Addendum # 1

Bid Opportunity: 24-7556-RFT – Waterloo-Oxford District Secondary School Family Studies Renovation & HVAC Upgrades

.1 REFER TO THE ATTACHED MECHANICAL & ELECTRICAL ADDENDUM #1 PREPARED BY MNE ENGINEERING LTD. DATED 12 APRIL 2024 (9 PAGES).

To:	Cornerstone Architecture	Date:	April 12, 2024
		Project:	Waterloo-Oxford District Secondary School Family Studies Renovations & HVAC Upgrades
cc:	WRDSB	Project No:	24008

CORNERSTONE
 ARCHITECTURE

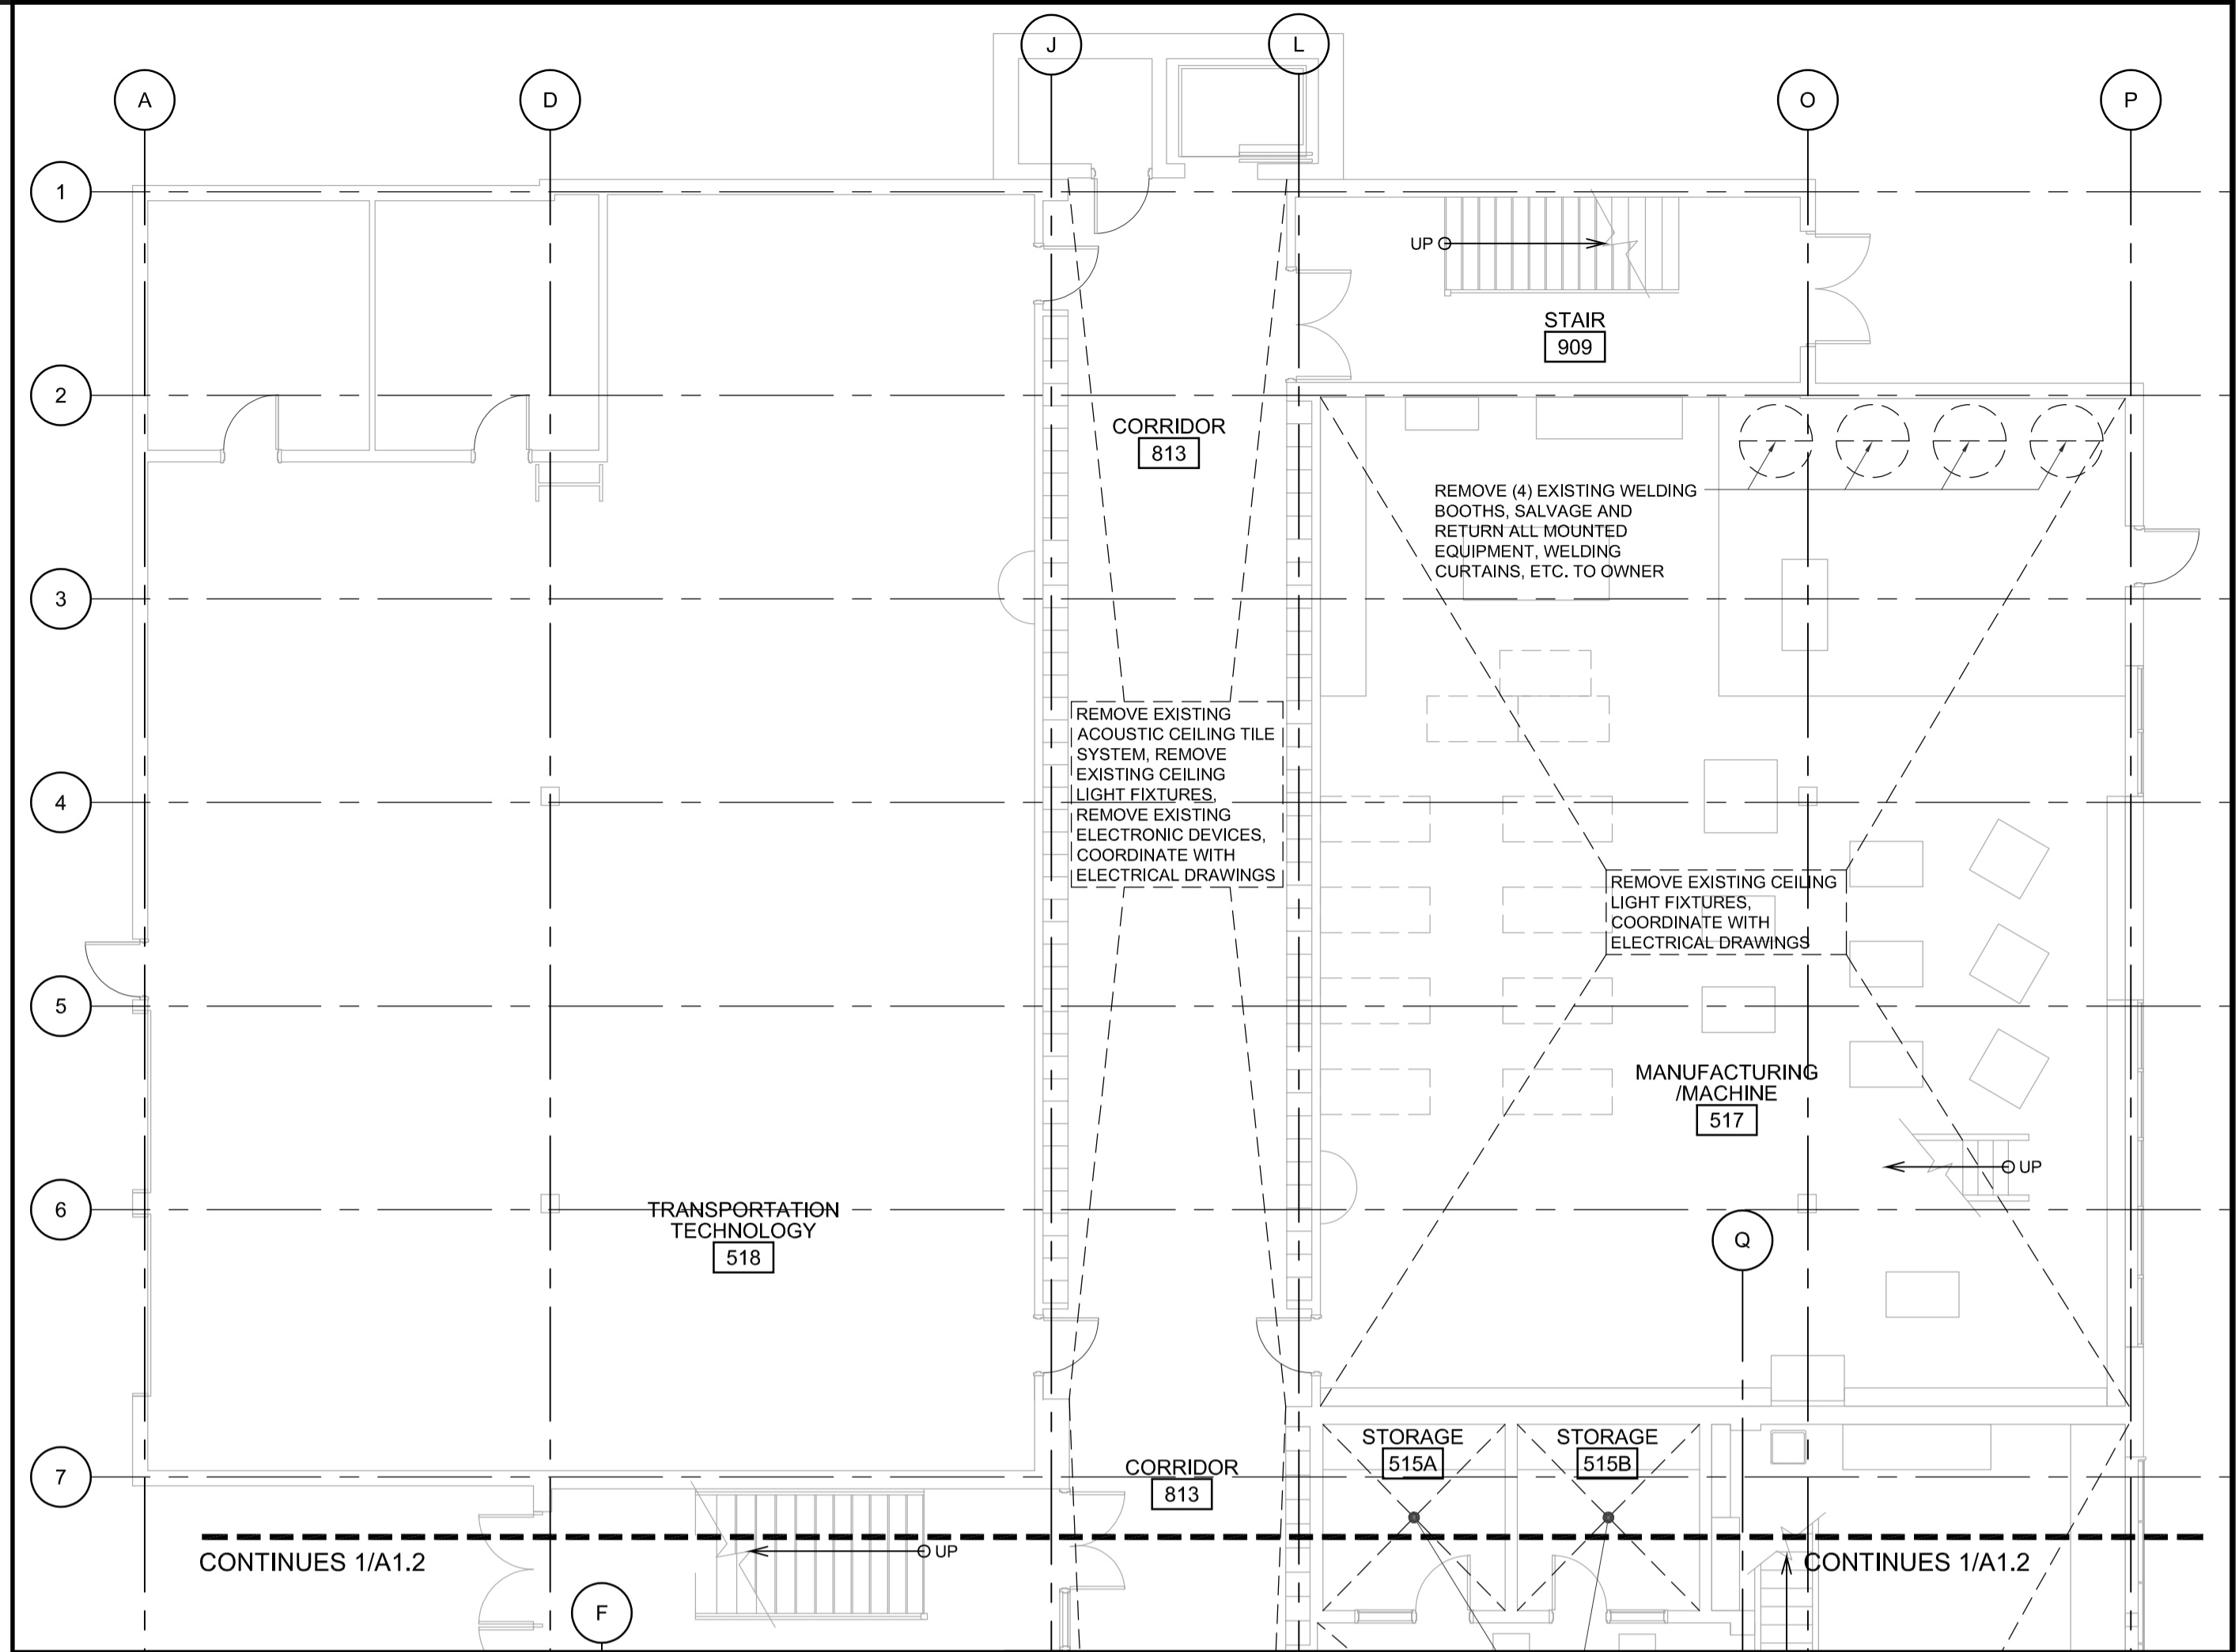
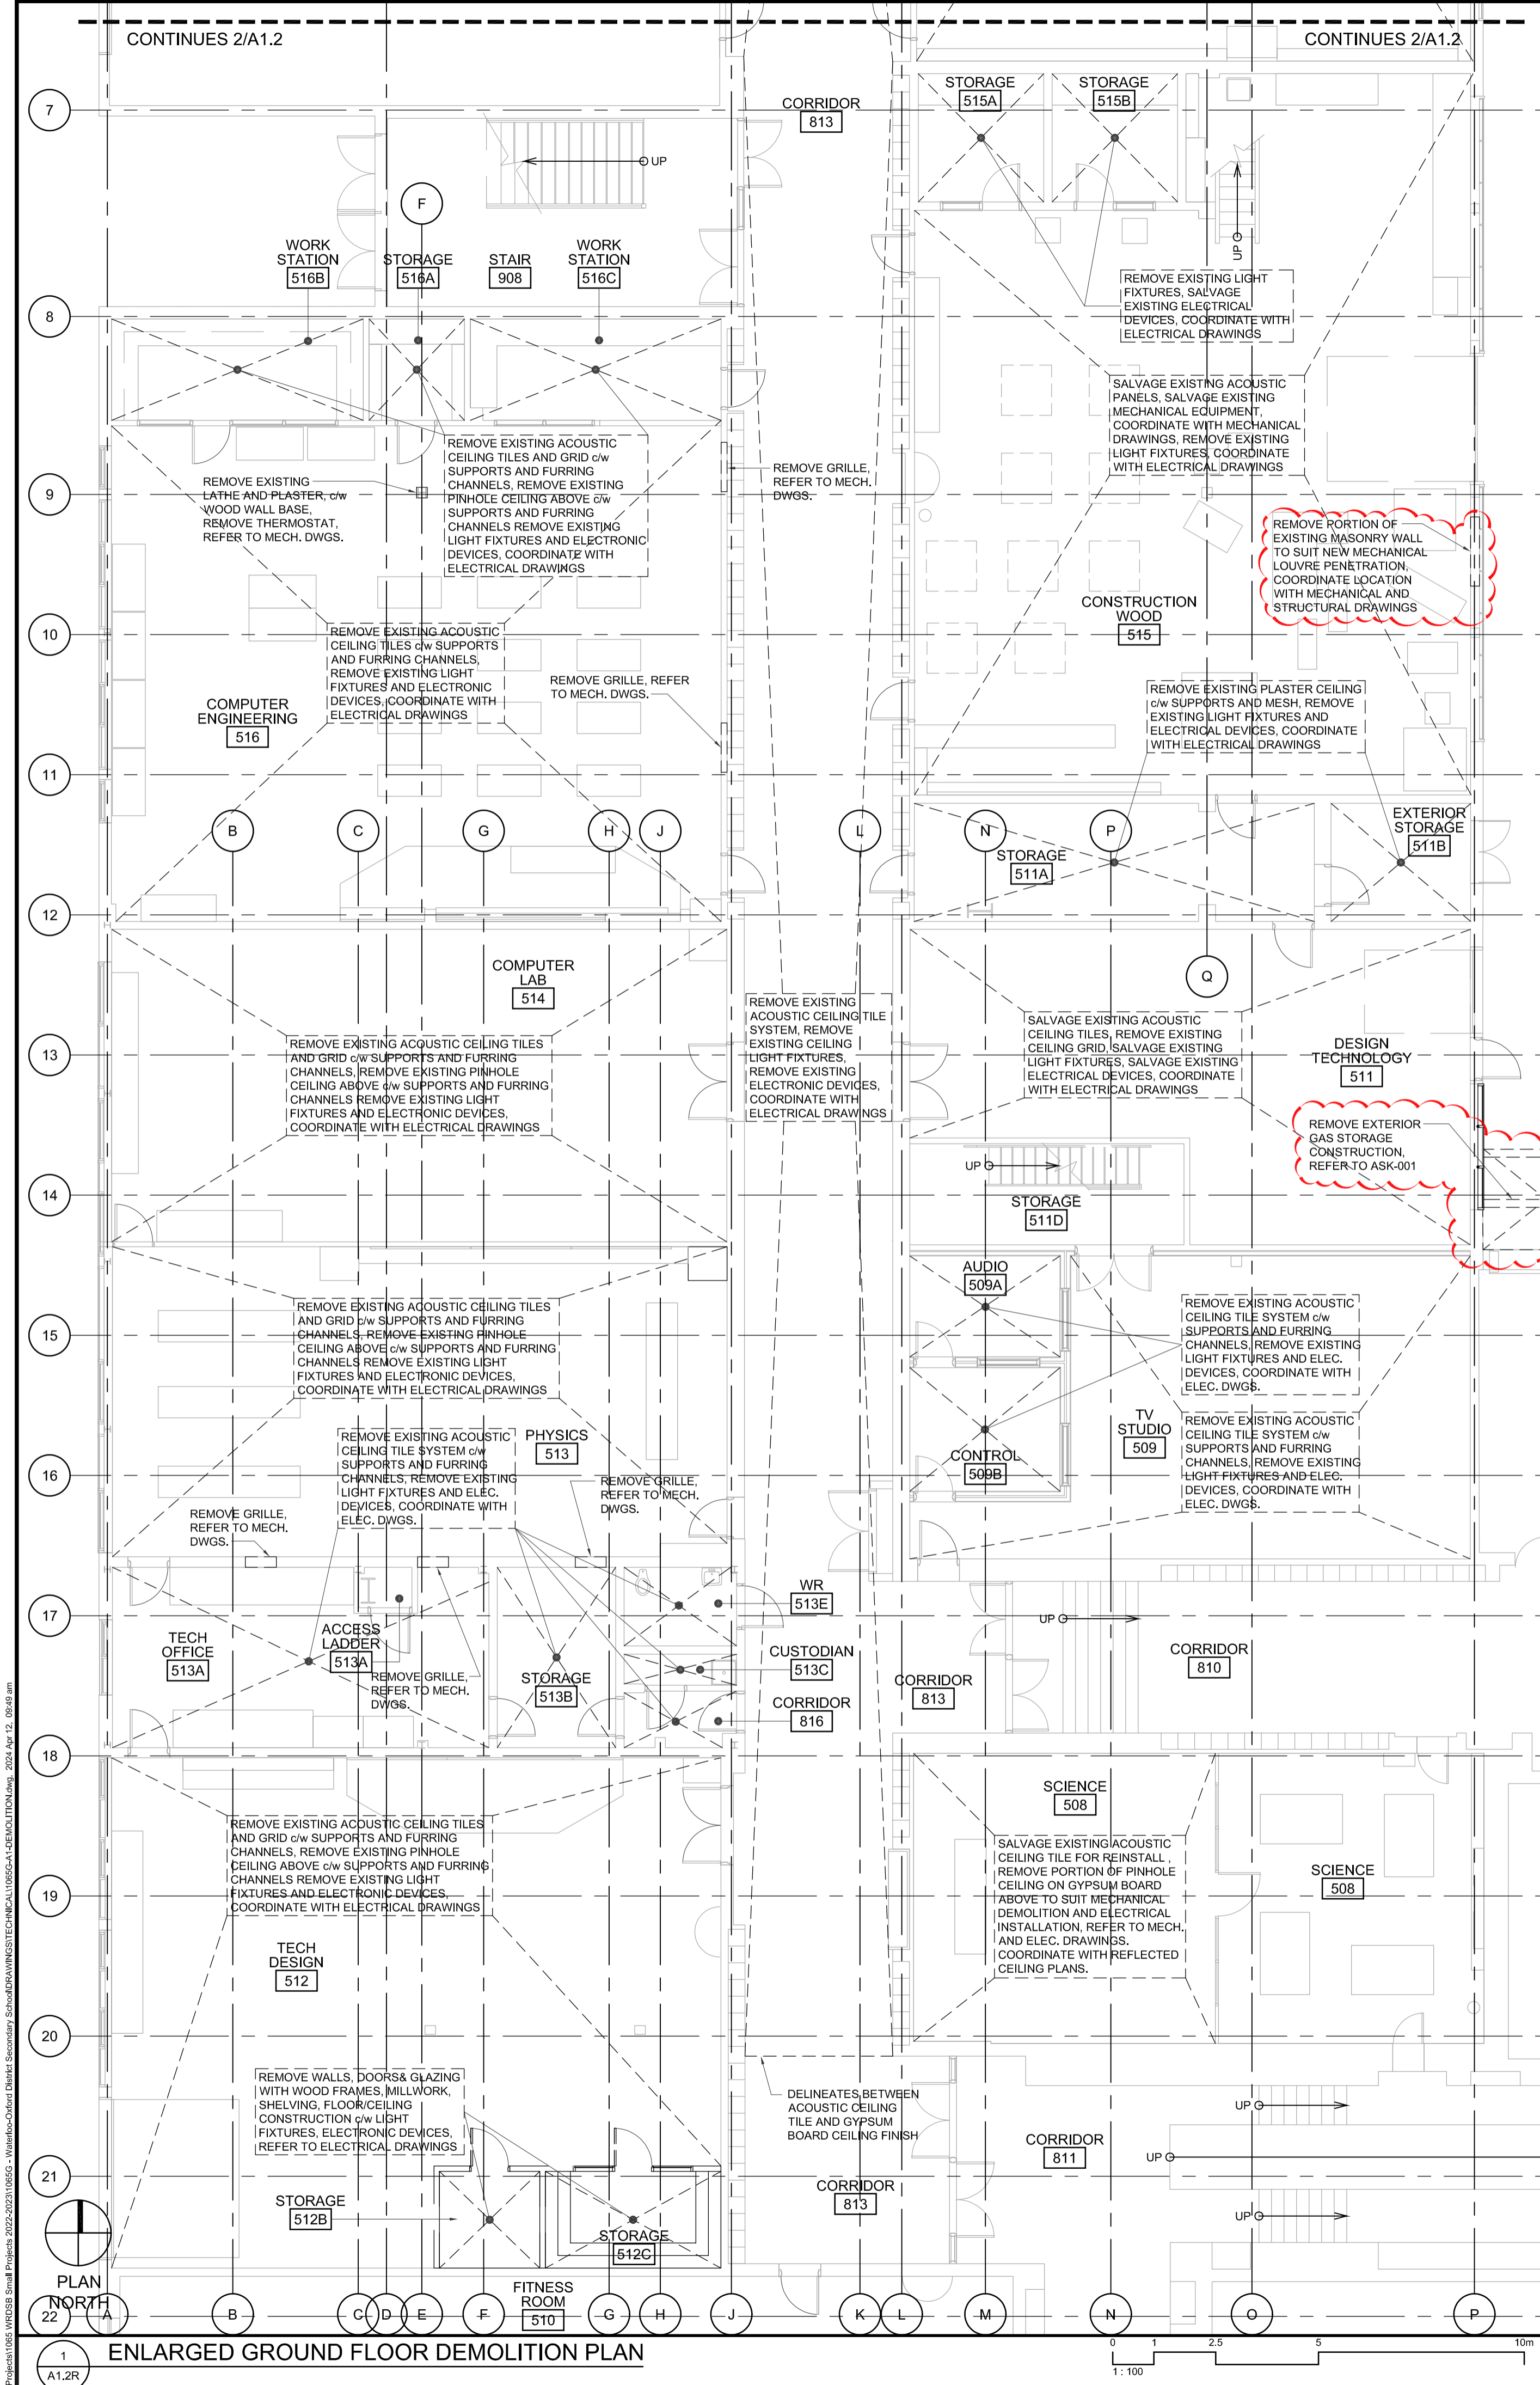
.2 **REFER TO DRAWING ASK-001, ATTACHED, FOR DEMOLITION OF EXTERIOR GAS STORAGE AREA.**

REMOVE EXISTING GAS STORAGE ENCLOSURE IN ITS ENTIRETY INCLUDING: ALL ROOFING MATERIAL, CONC. BLOCK WALLS, CHAIN LINK FENCING, GATES, AND POSTS. REMOVE FLASHING AND CLEAN OFF ADHESIVES AT EXISTING EXTERIOR WALLS

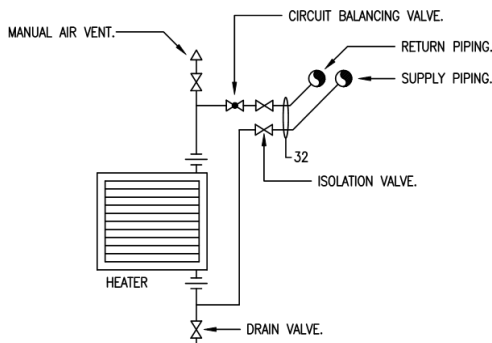
2. Reference M1.3
 - a. Add Unit Heater Piping Detail as per below:

DRAWING: 511A STORAGE REVISIONS

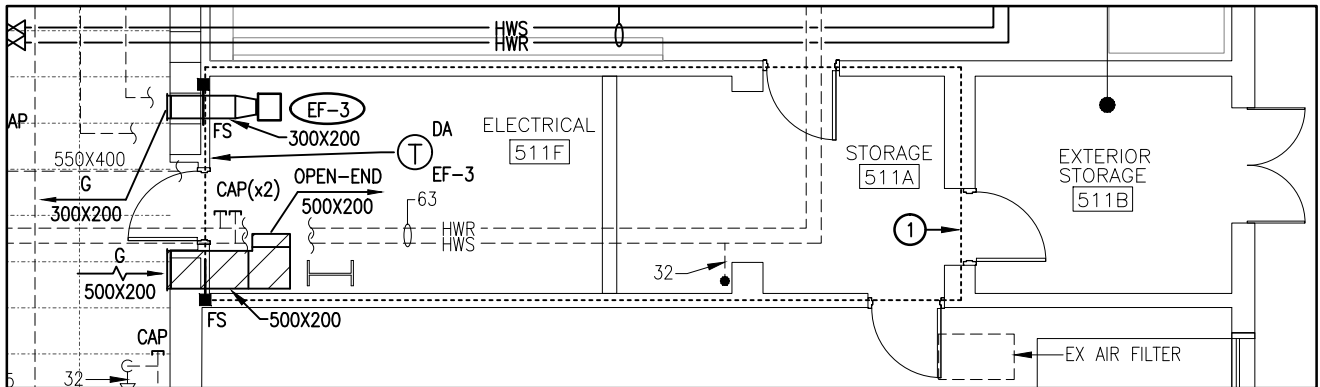
4. Reference 1/M2.1 and 1/M3.1
 - a. Revise 511A Storage as per attached sketch SK-M01.
 - b. Revise 515A and 515B room names to 515A Storage and 515B Storage.

EXHAUST FAN SCHEDULE

SYMBOL	DESCRIPTION	SUPPLIER & MODEL	REMARKS
EF-3	ELECTRICAL ROOM EXHAUST FAN 240 CFM (115 L/S) AT 0.3" WC (0.06 KPA) ESP	PENNBARRY ZEPHYR Z8H	120-1-60, 1.6 AMPS. PROVIDE PLUG TYPE DISCONNECT, THERMAL OVERLOAD PROTECTION, BACKDRAFT DAMPER, SPEED CONTROLLER, TYPE 'RA' DISCHARGE (CEILING MOUNTED) C/W CEILING GRILLE, WALL-MOUNTED 120V DIRECT ACTING THERMOSTAT, NEOPRENE ISOLATORS AT ALL SUPPORT POINTS.

DRAWING: 517 WELD BOOTH REVISIONS

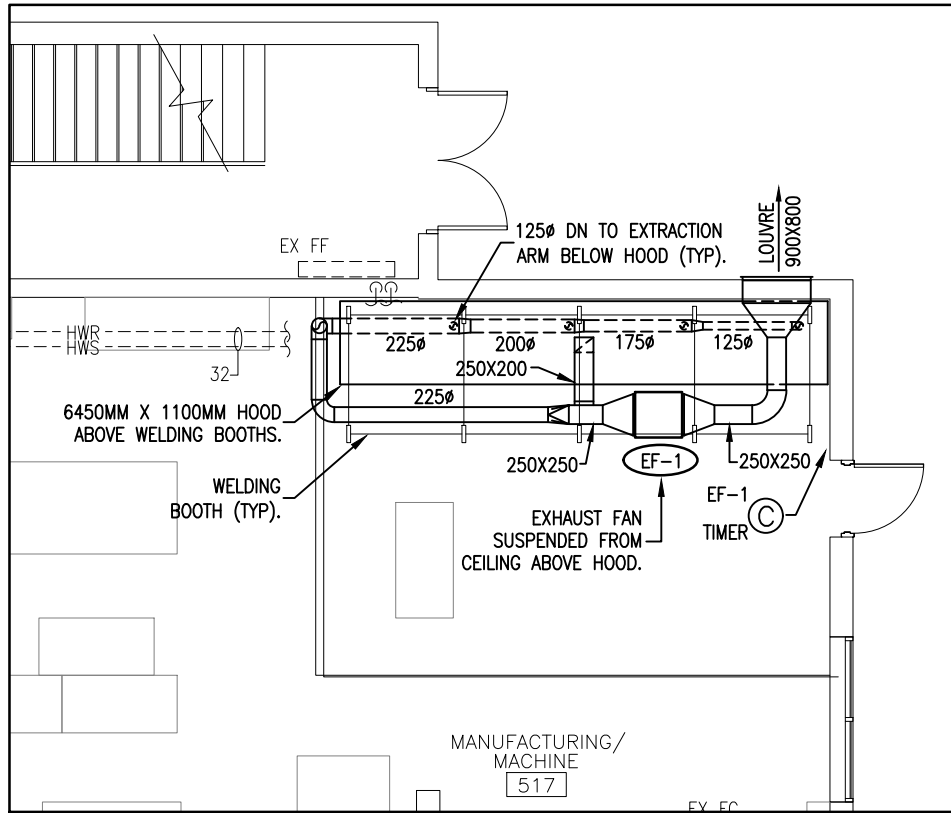
- d. Add note 21 at force flow heater in Stair 908.
11. Reference 2/M3.1
 - a. Revise weld booth exhaust air system in 517 Manufacturing/Machine as per attached sketch SK-M02.

SYMBOL	DESCRIPTION	SUPPLIER & MODEL	REMARKS
EF-1	WELDING EXHAUST FAN 1500 CFM (710 L/S) AT 4.4" WC (1.09 KPA) ESP	COOK 165SQN-HP	575-3-60, FLA=3.9 AMPS, 3 HP. PROVIDE PREMIUM EFFICIENCY BELT-DRIVE MOTOR, THERMAL OVERLOAD PROTECTION, PERMANENTLY LUBRICATED BALL BEARING MOTOR, GRAVITY BACKDRAFT DAMPER, BELT GUARD, FLANGED INLET/OUTLET, SPEED CONTROLLER, NEOPRENE ISOLATORS AT ALL SUPPORT POINTS.
